Review of Landscape and Visual Assessment

Land to the North East of KGV Playing Fields (Northaw Road East), Cuffley

LPA: Welwyn Hatfield Borough Council

Liz Lake Associates, 12th January 2016

Figure 1 Photo Locations

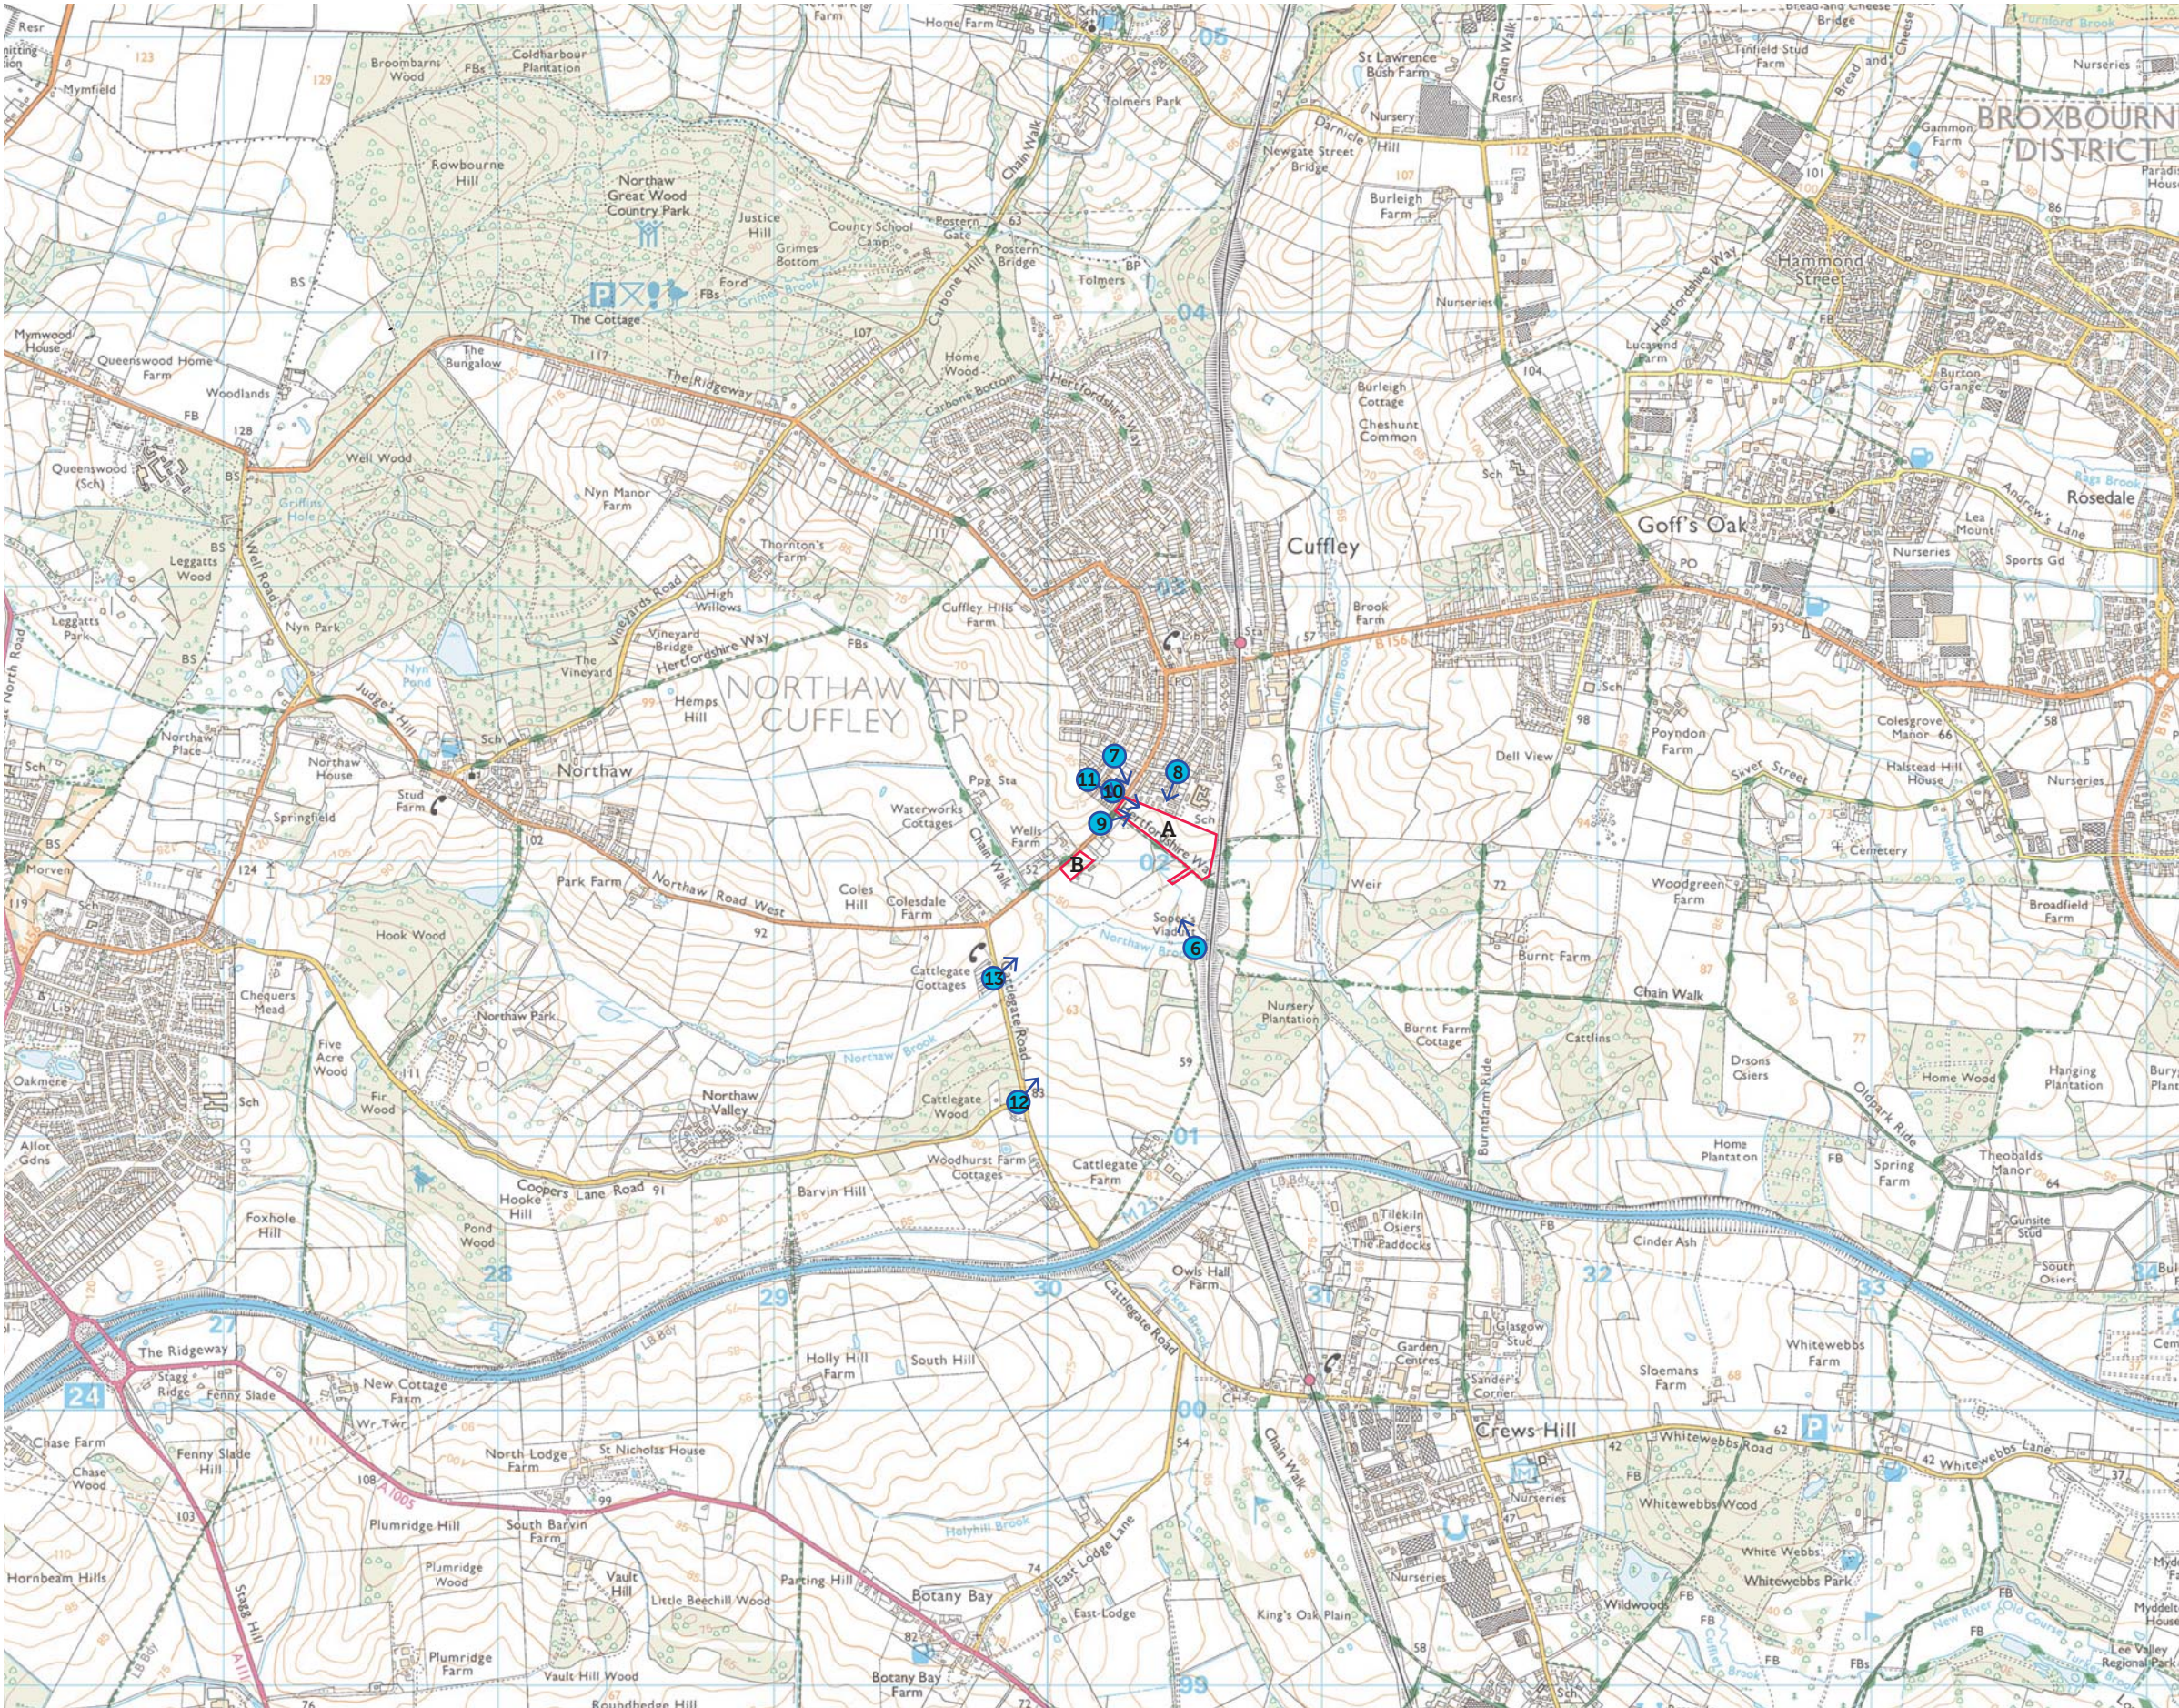
- There are oblique views from properties and gardens in the vicinity of Greenfields/ South Drive west of the School.
- There are views from South Drive itself extending back to Theobold's Road (see LLA VP5 and VP8) within the settlement.

- There are views of the site from Burleigh Way and Kingsway on elevated ground west of Northaw Road East, which have not been identified (see LLA VP7).

- There are views of the site from elevated properties in the vicinity of Burleigh Way, Kingsway, Kingswell Ride and other residential properties – see the reverse views from site towards the elevated residential areas (LLA VP6).
